AMENDMENT OF SOLICITATION/MODIFICATION OF CONTRACT				1. CONTRACT ID CODE		PAGE OF PAGES		
2. AMENDMENT/MODIFICATION NO.			3. EFFECTIVE DATE		4. REQUISITION/PURCHASE REQ. NO.		5. PROJECT NO. (If applicable)

4. Delete Sheets G-001, P-104, M-101, M-504, M-602, MI105, and MI108 and replace with the attached Sheets G-001, P-104, M-101, M-504, M-602, MI105, and MI108.

REPAIR BEQ HP510

PROJECT NO.: 18-0042

2 MECHANICAL BUILDING NEW WORK NATURAL GAS PLAN
SCALE: 1/4" = 1'-0"

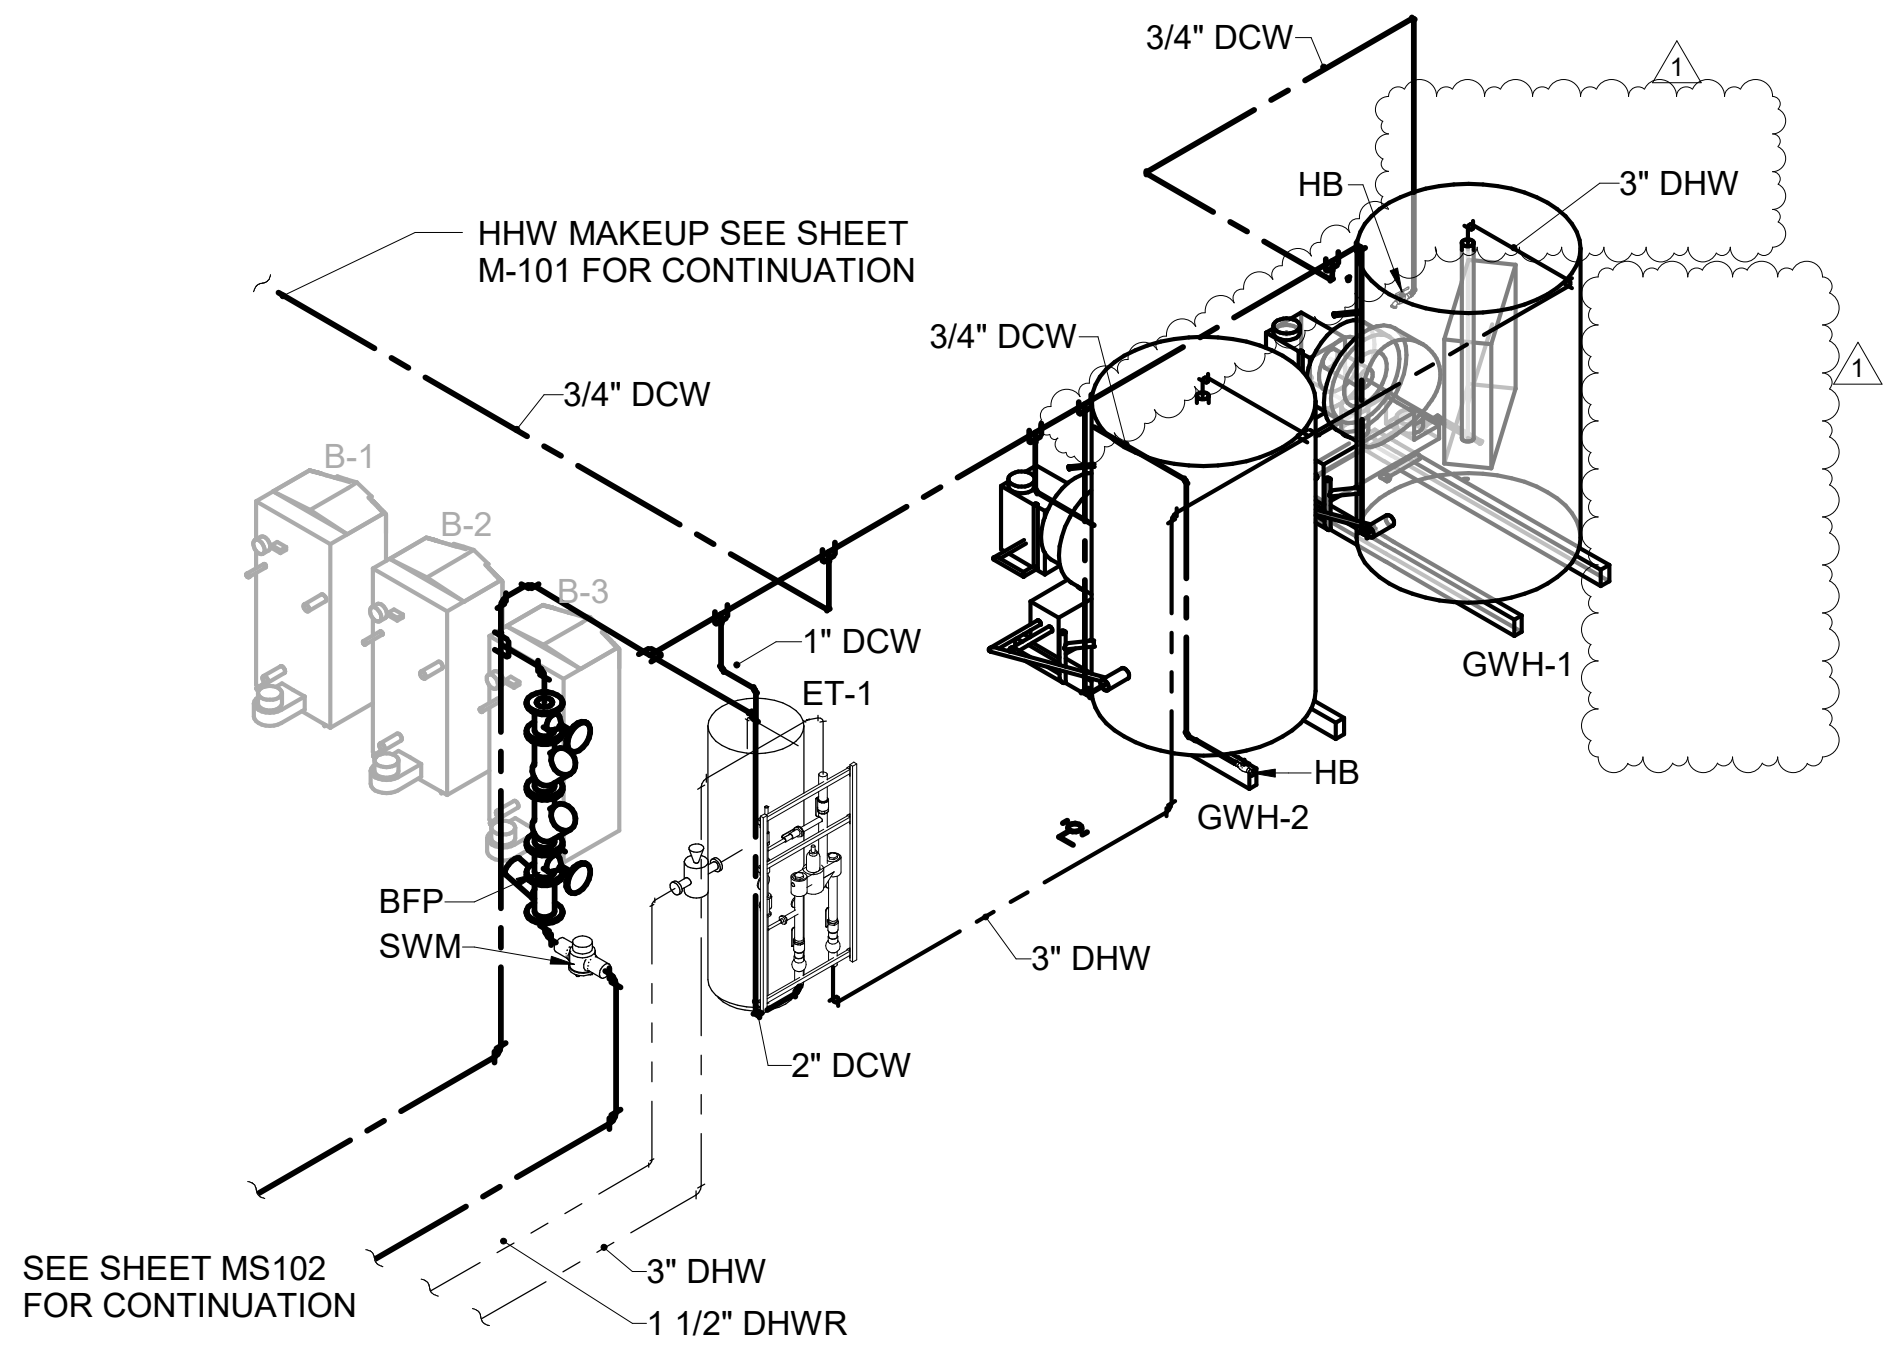
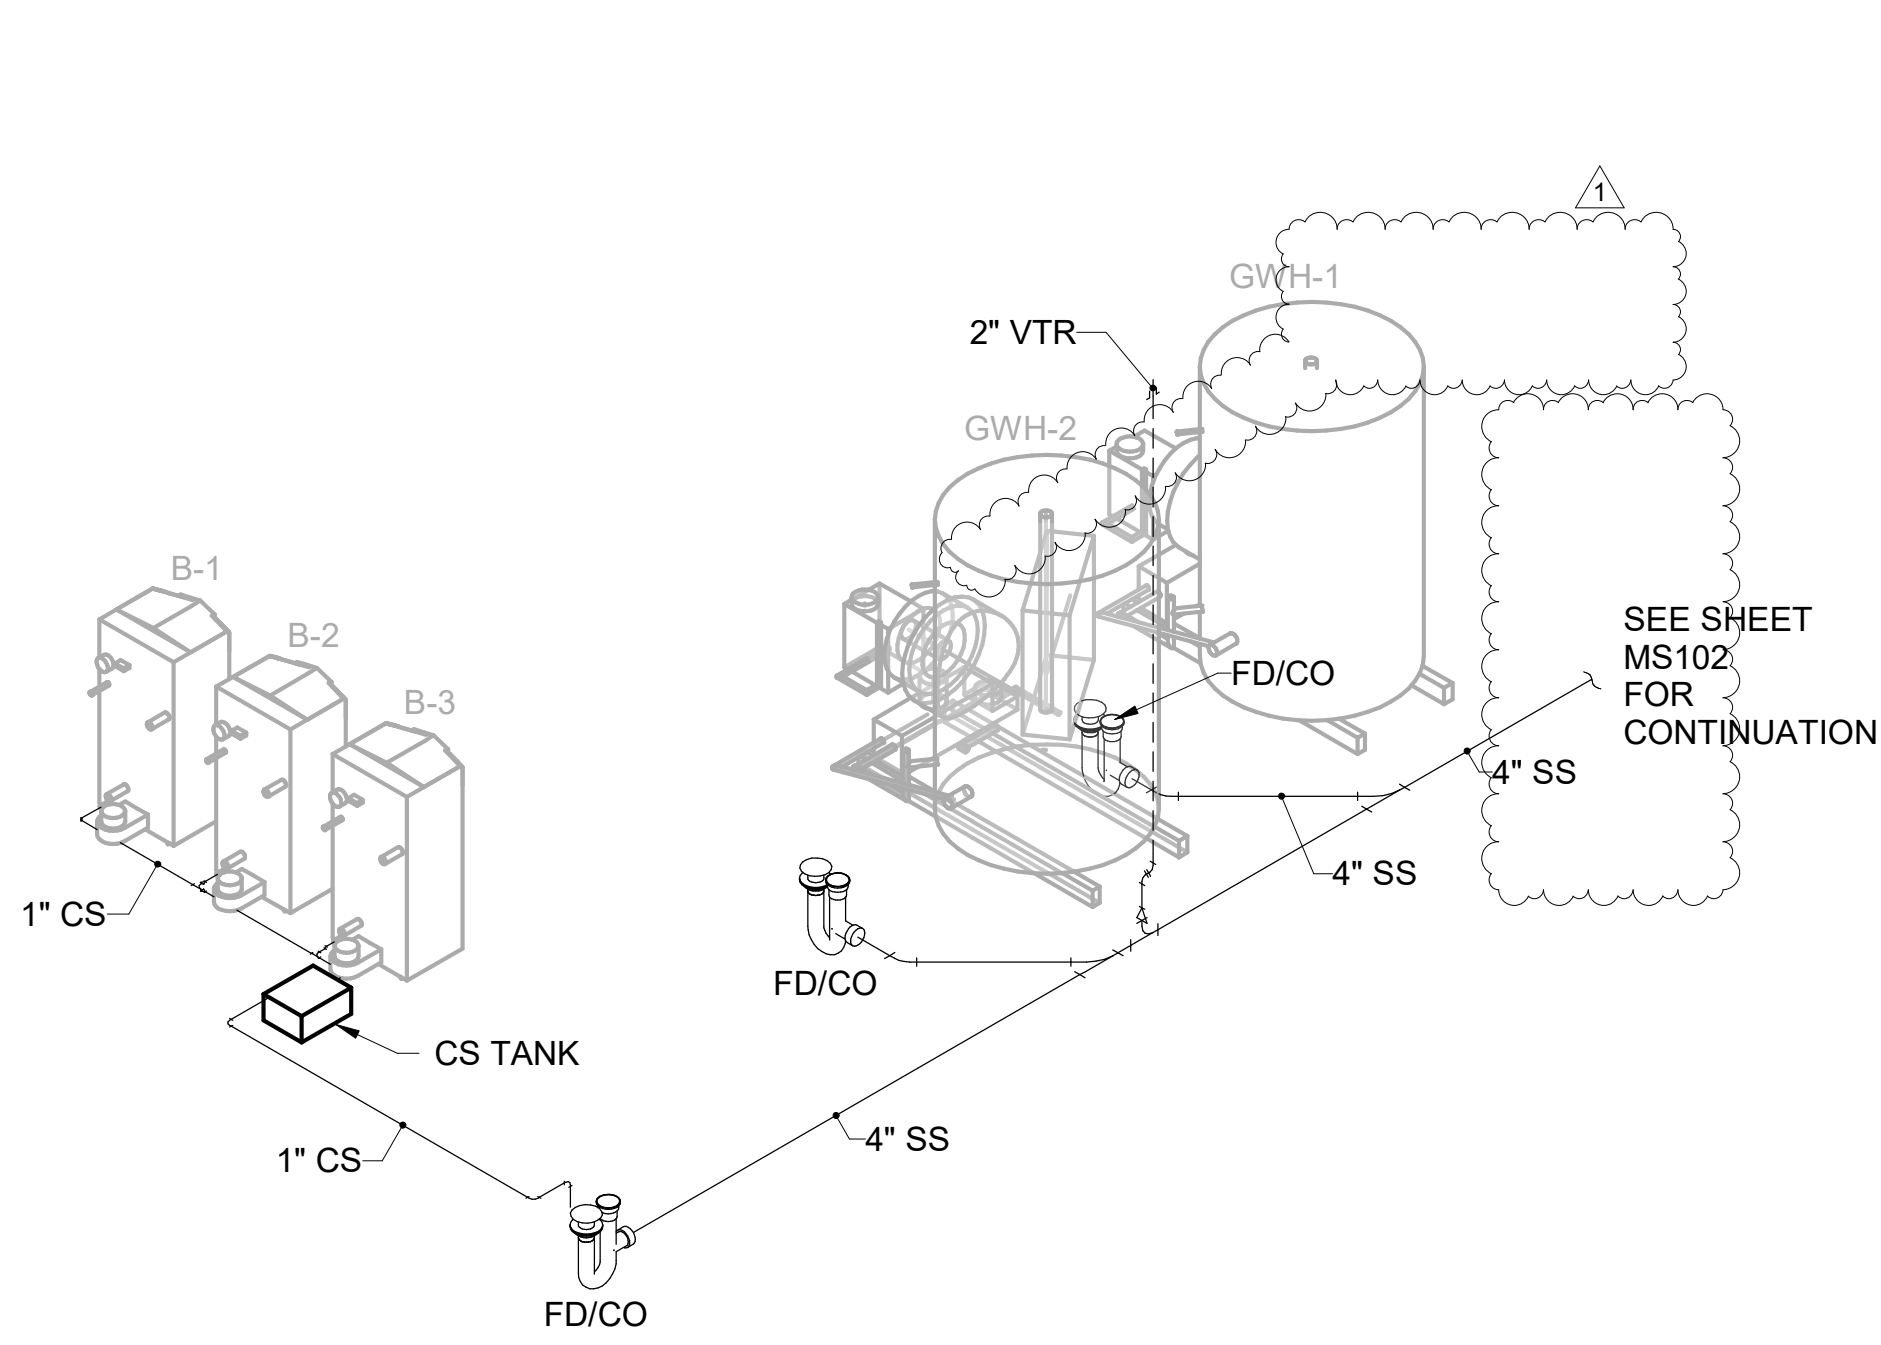
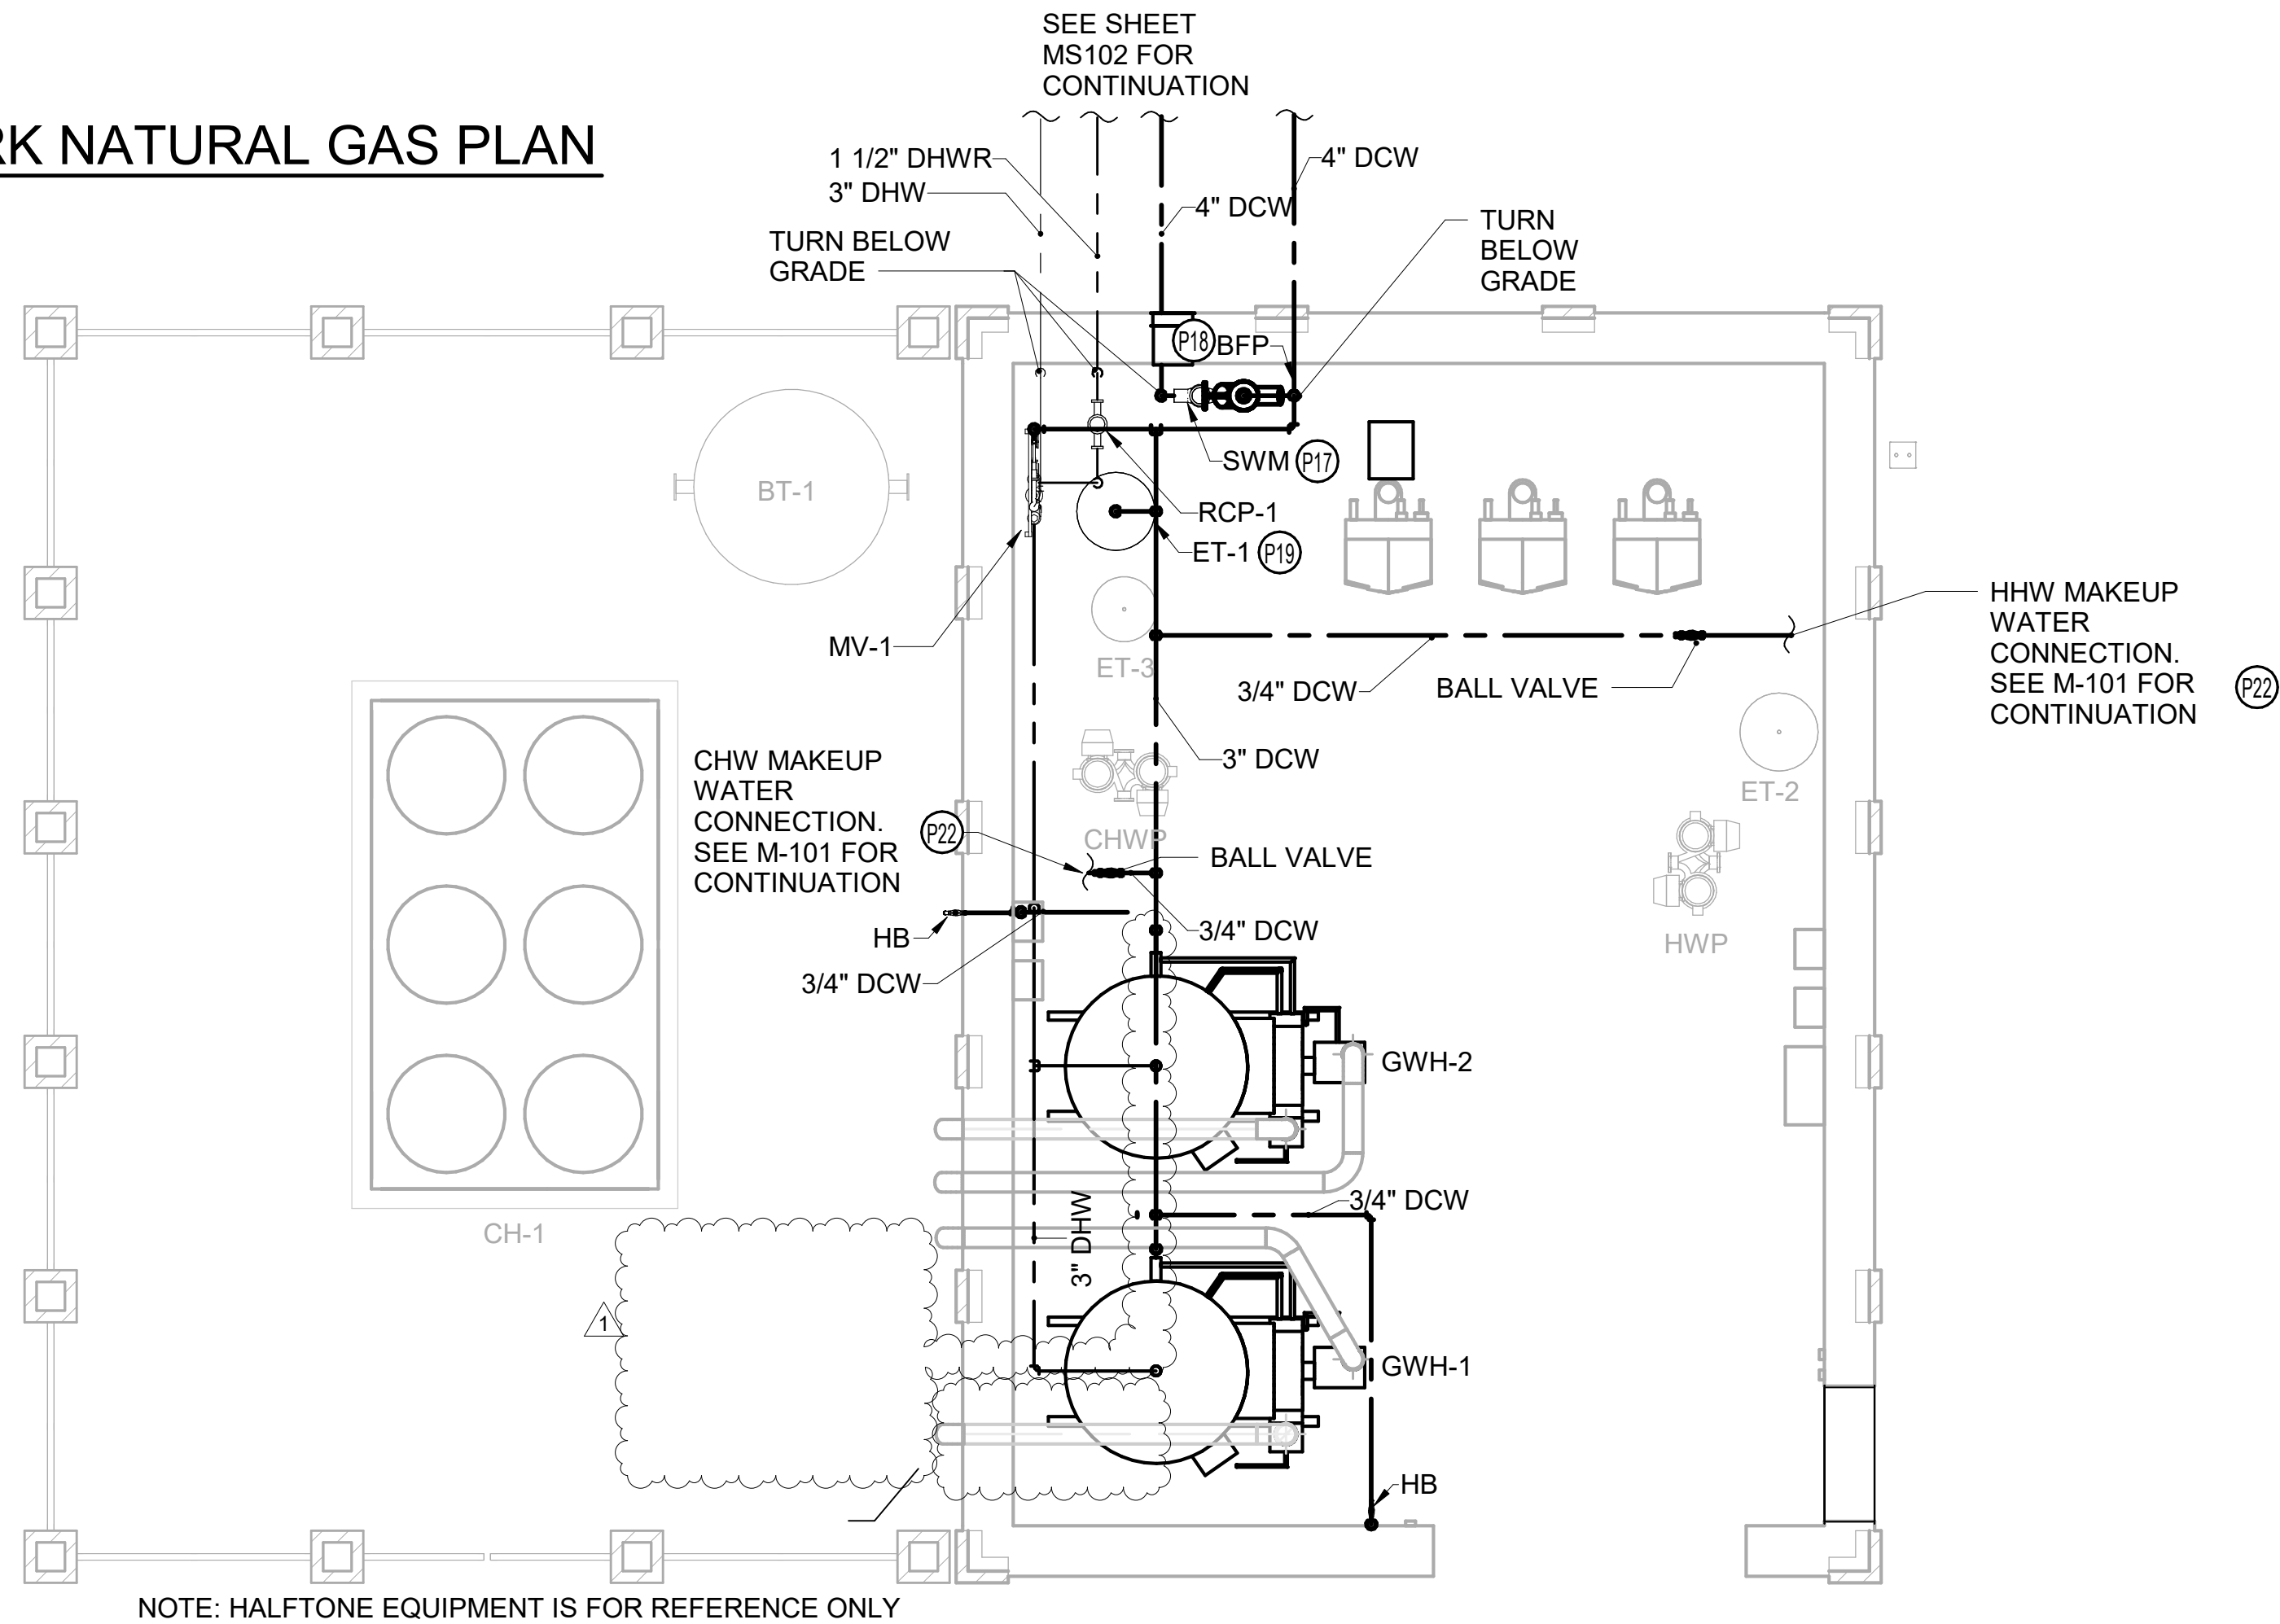
REVISIONS			
SYM.	DESCRIPTION	DATE	APPROVED
1	REMOVE ALL HEAT RECOVERY SYSTEMS	08/10/20	PCM
